### **General Plan/LCP Implementation Committee**

# CITY OF NEWPORT BEACH GENERAL PLAN/LCP IMPLEMENTATION COMMITTEE

Questions from Barry Eaton Third Draft Zoning Code Parts 5-7. Staff responses in **bold**.

Subject: City of Newport Beach – 3rd Draft Zoning Code Update Review Comments

## B-6 Ocean Boulevard / Breakers Drive

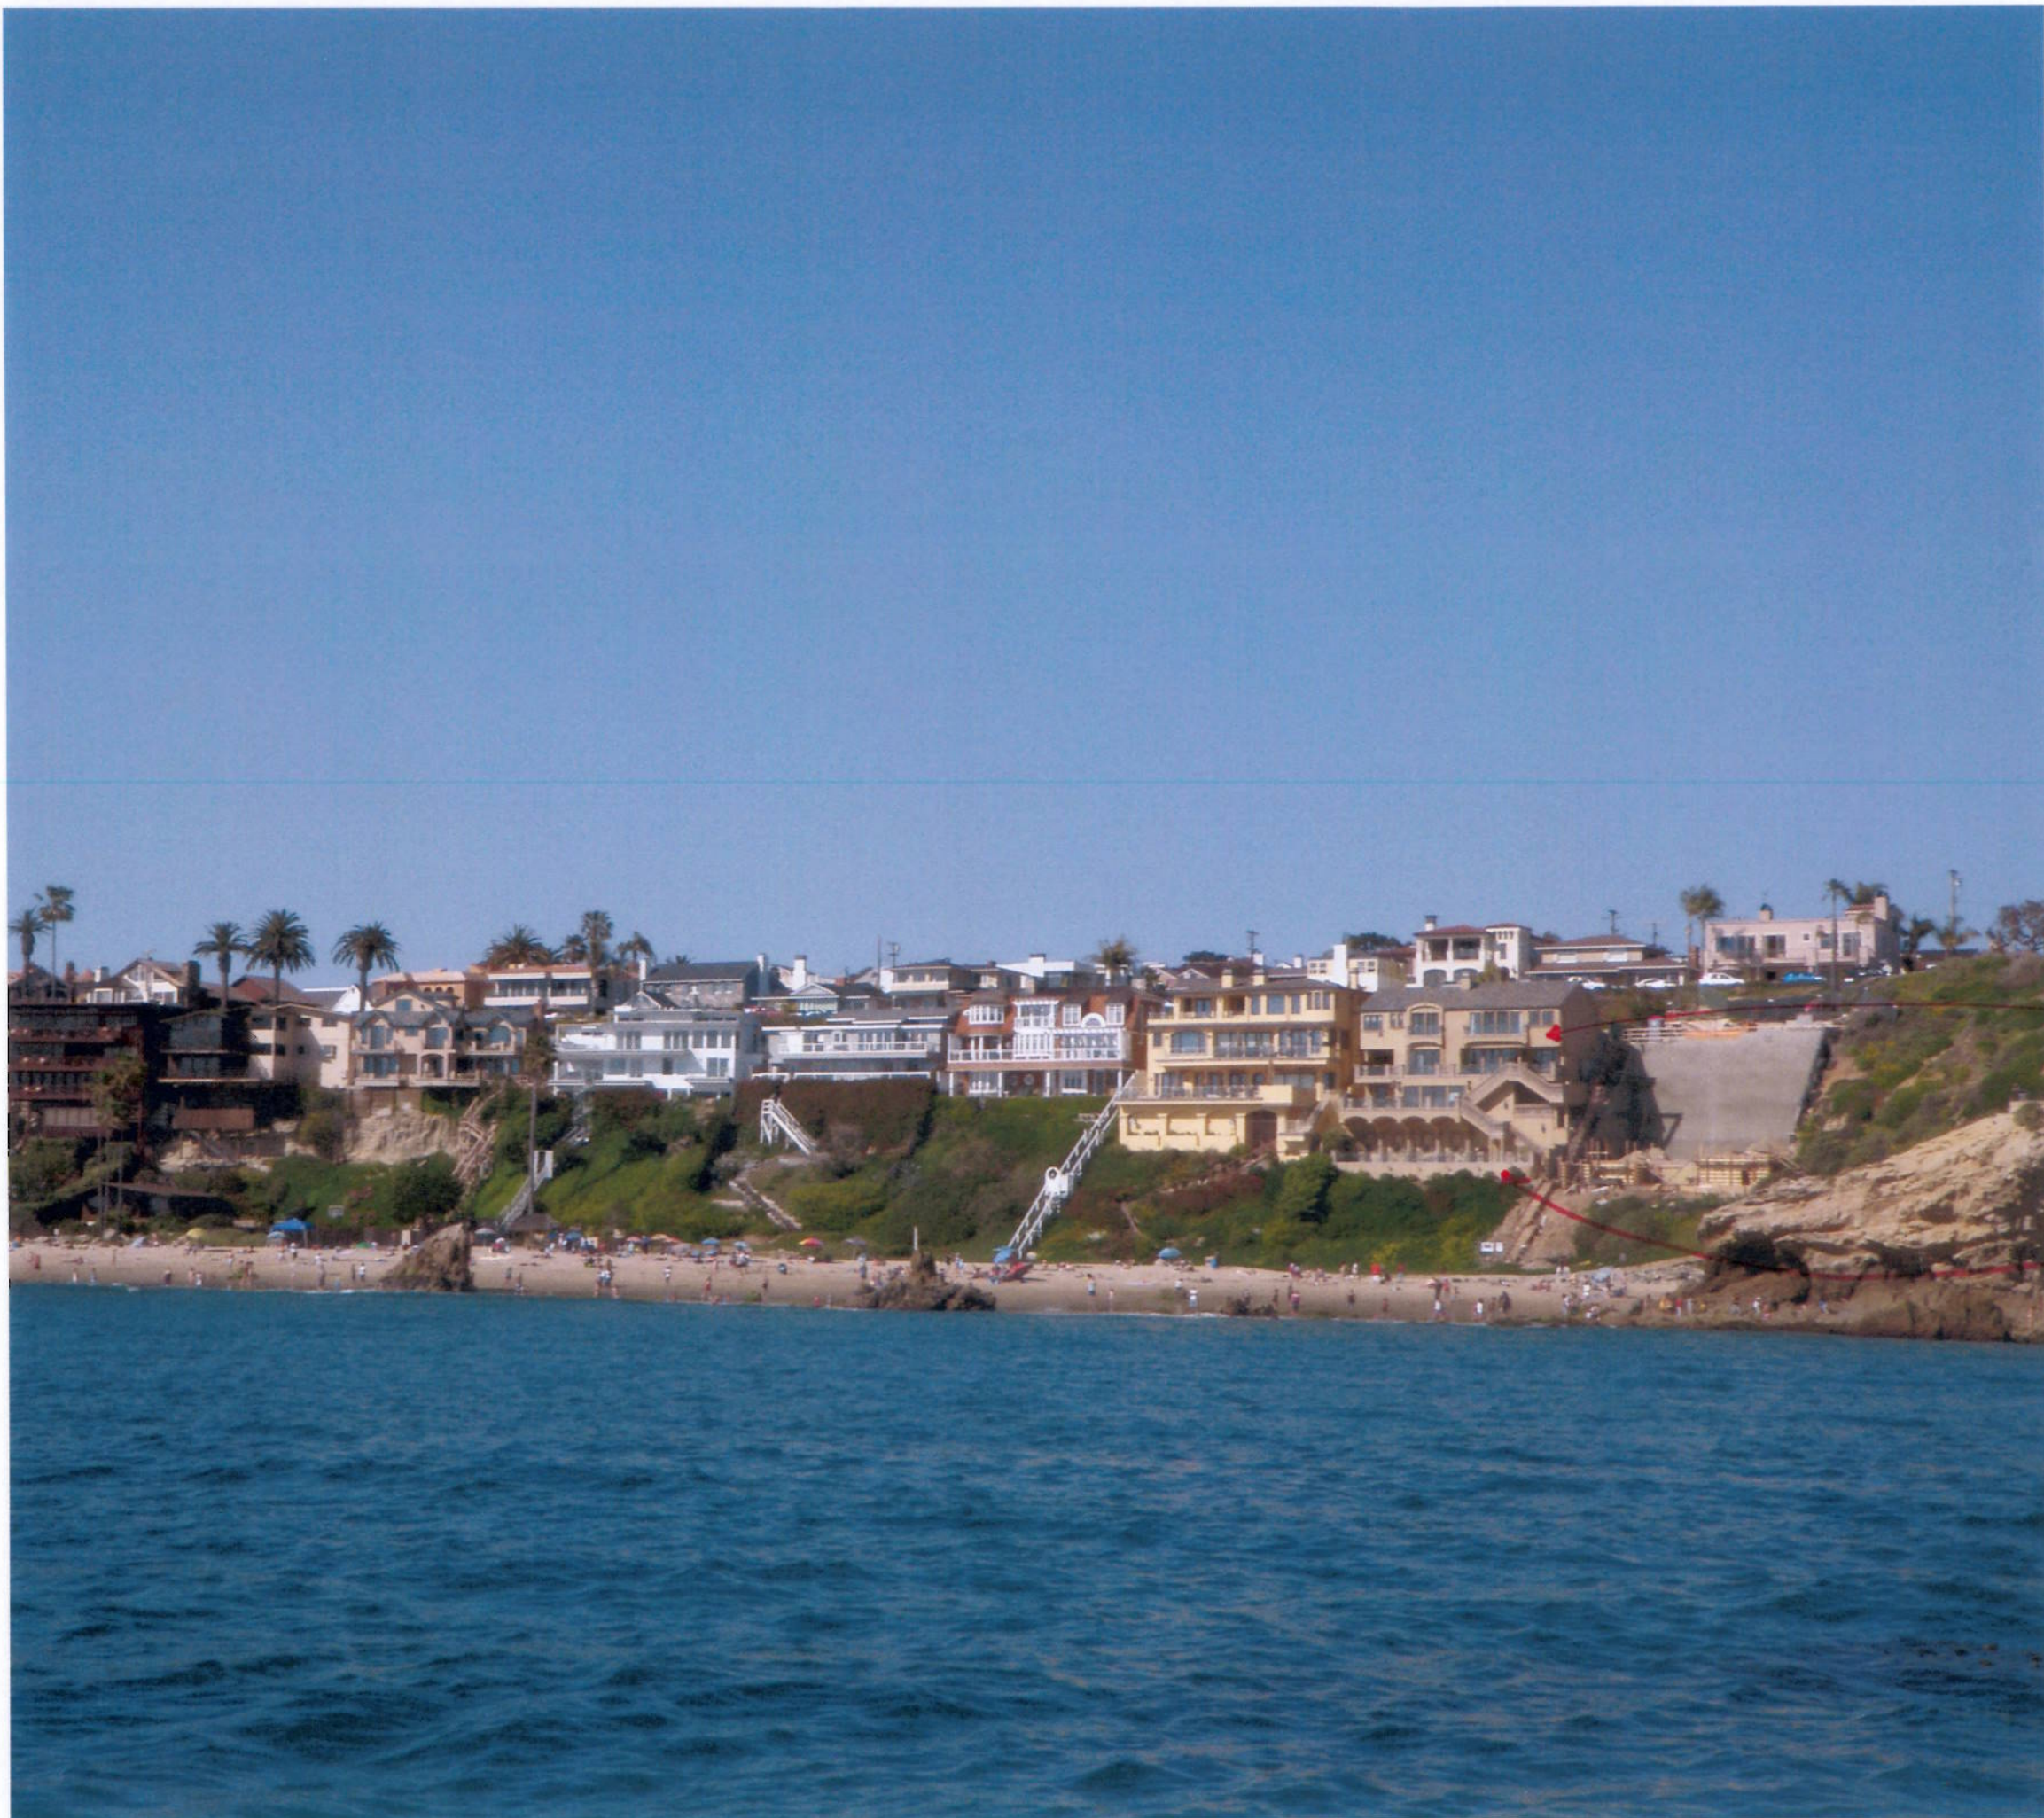
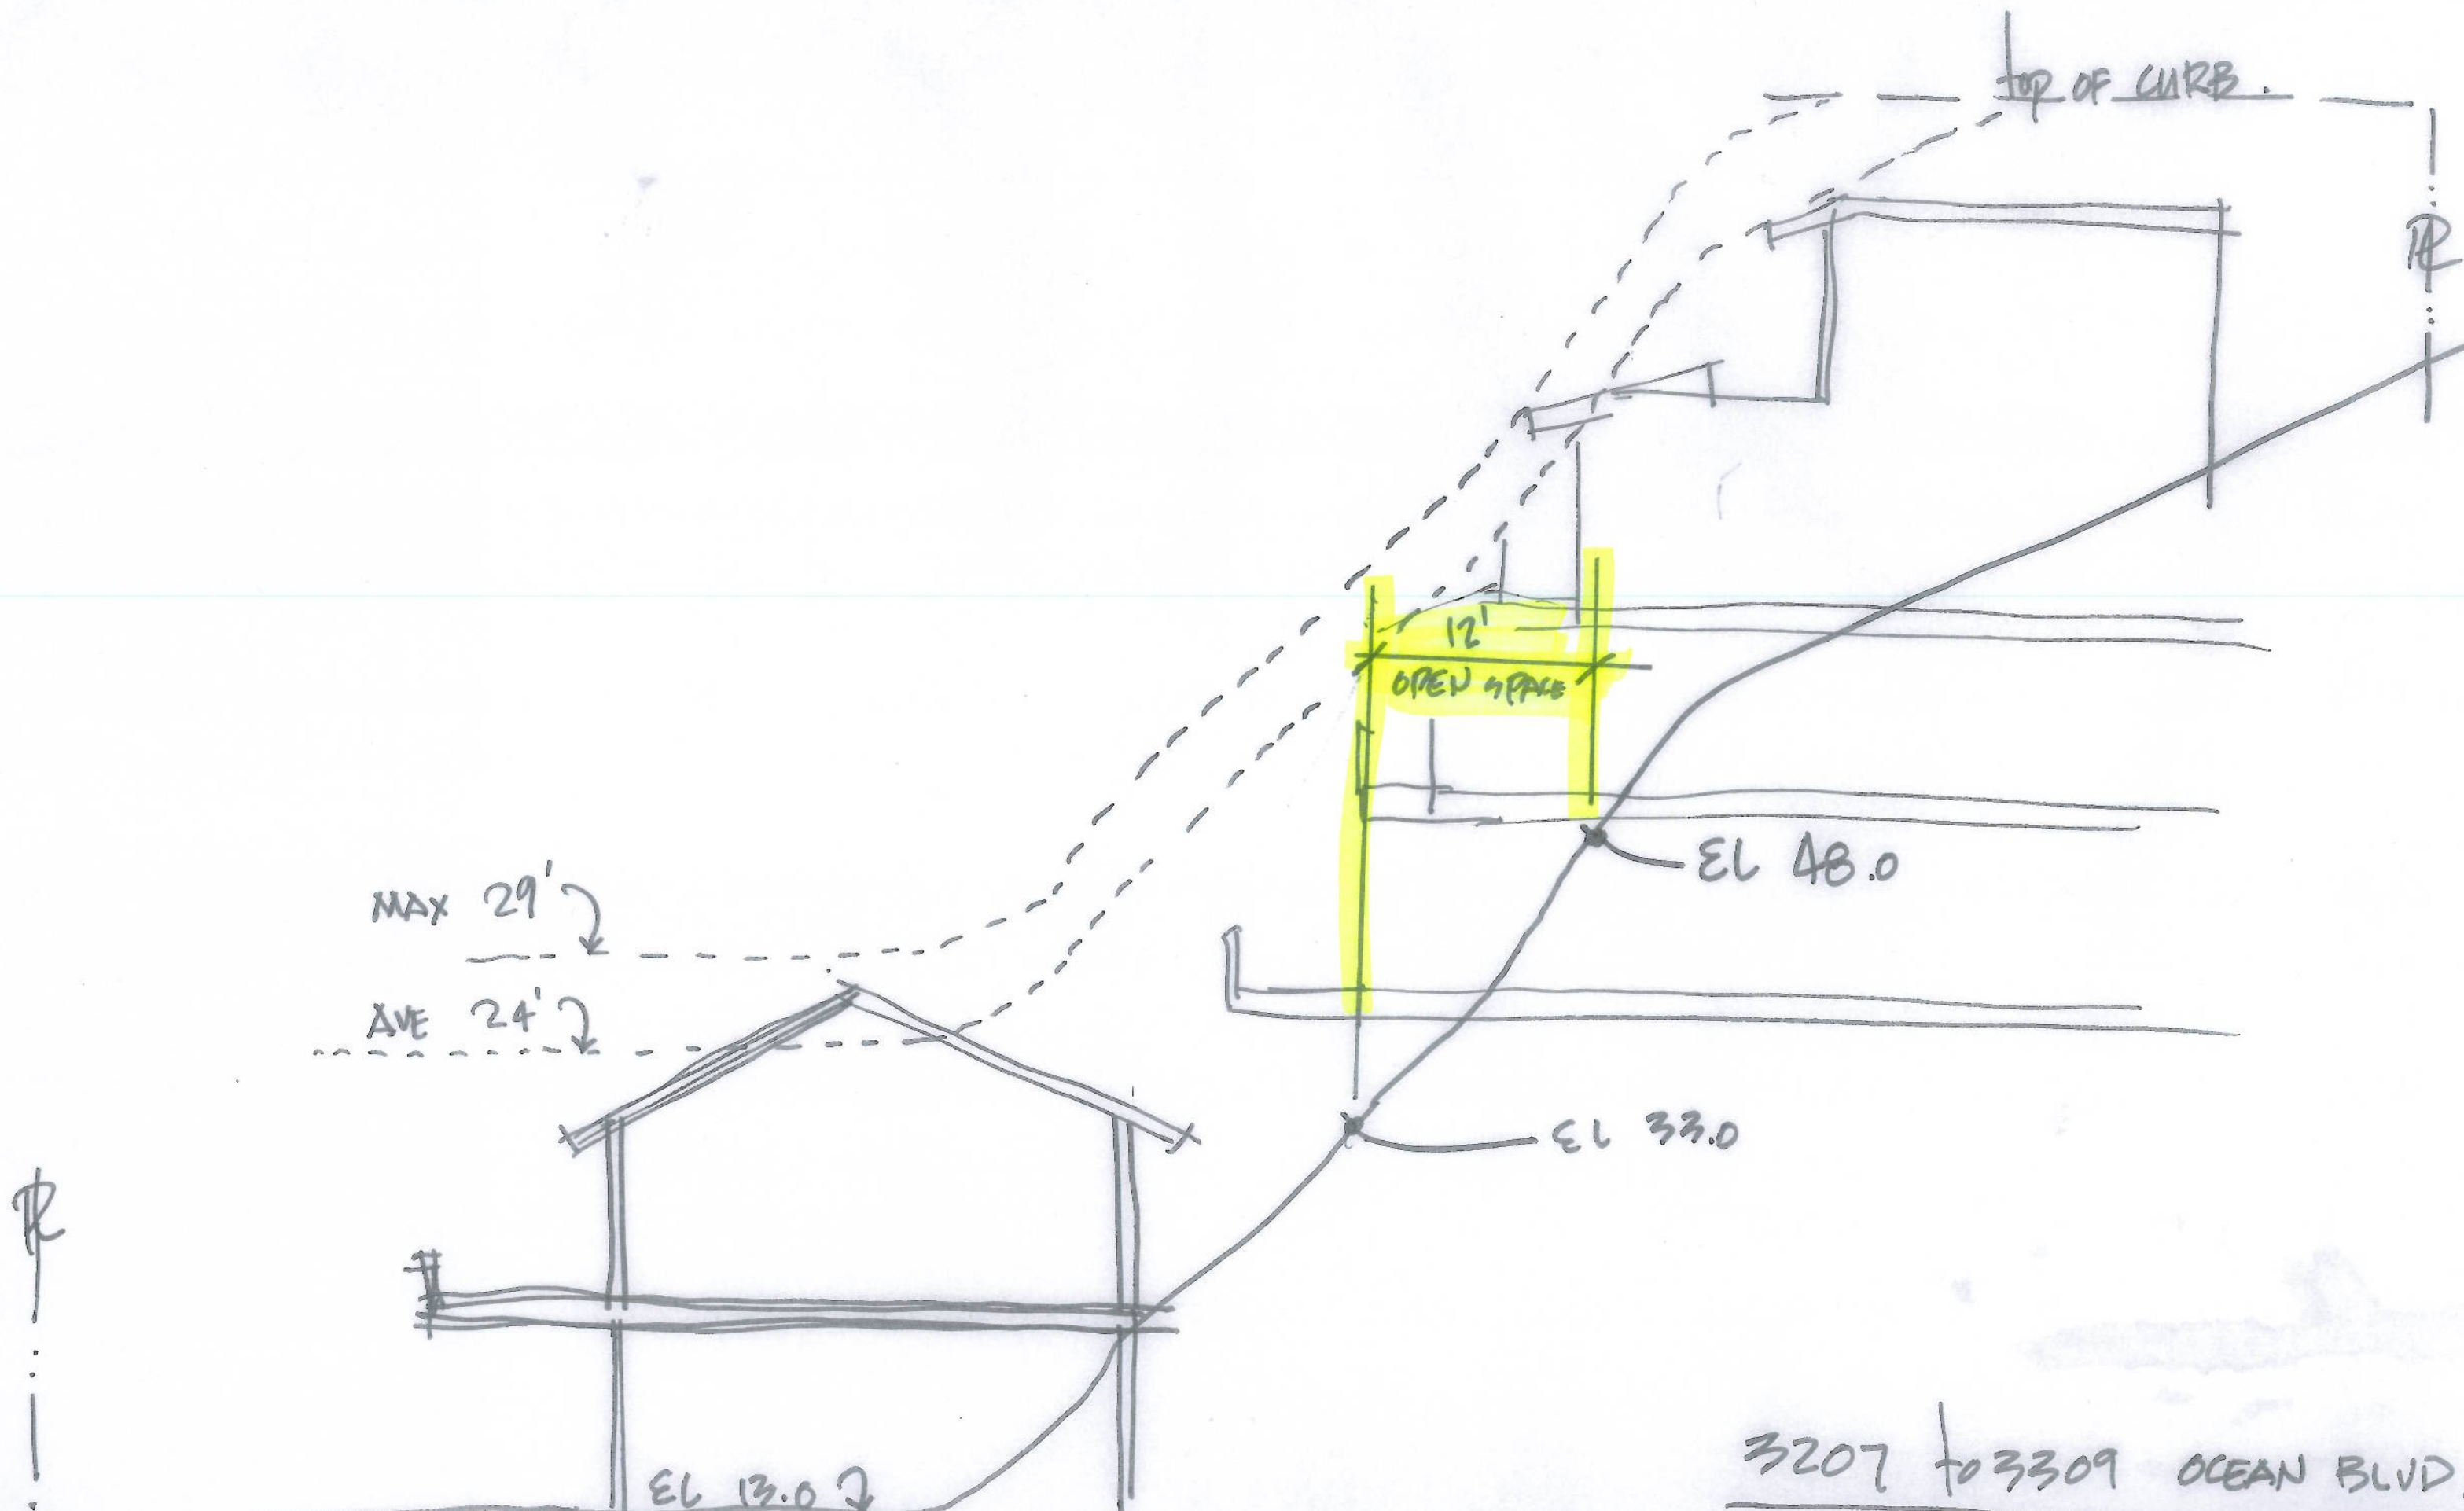
287) Has Map B-6 (showing the buildable areas of the lots south of Ocean Blvd.) now been changed as to areas designated as Development Area B and Development Area C?

**This was intended to be Area C. Staff is re-evaluating recommendation.**
